# Shunt Tube/Alternator Bracket Bolt Interference

# 20-21

Freightliner  
Service Bulletin

Fig. 1

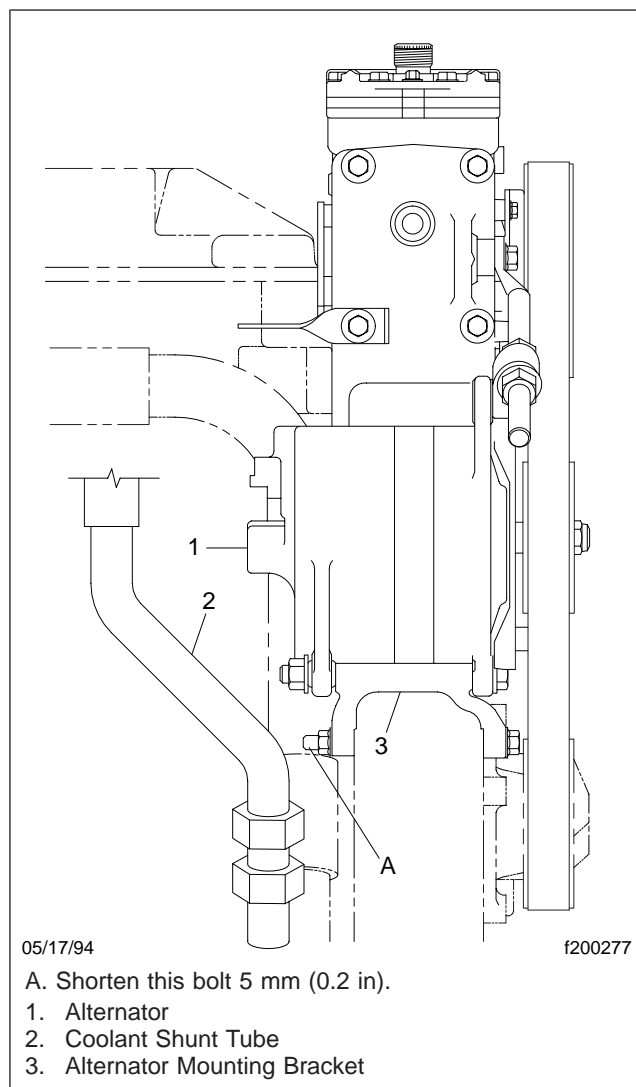
As of February 4, 1994, production changed over to a new steel shunt tube on DDC Series 60 engines, to eliminate routing problems. The new steel shunt tube may rub on the lower bolt of the alternator mounting bracket (one of the fasteners between the bracket and the engine). See Fig. 1. On FLB COE and FLD Conventional vehicles, the M10 x 1.5-145 mm bolt may possibly rub a hole in the shunt tube, causing loss of engine coolant. Production is now inspecting vehicles to ensure this interference does not occur, and by the end of May 1994, a shorter (140 mm) bolt will be installed in place of the current 145 mm bolt. This will prevent any interference problems.

If this interference problem is encountered in the field, remove the alternator mounting bracket bolt (with nut and washer), and grind approximately 5 mm (0.2 in) off the threaded end. If the shunt tube has been damaged, replace it as well. The tube (A05-16317-000) is available through the PDCs.
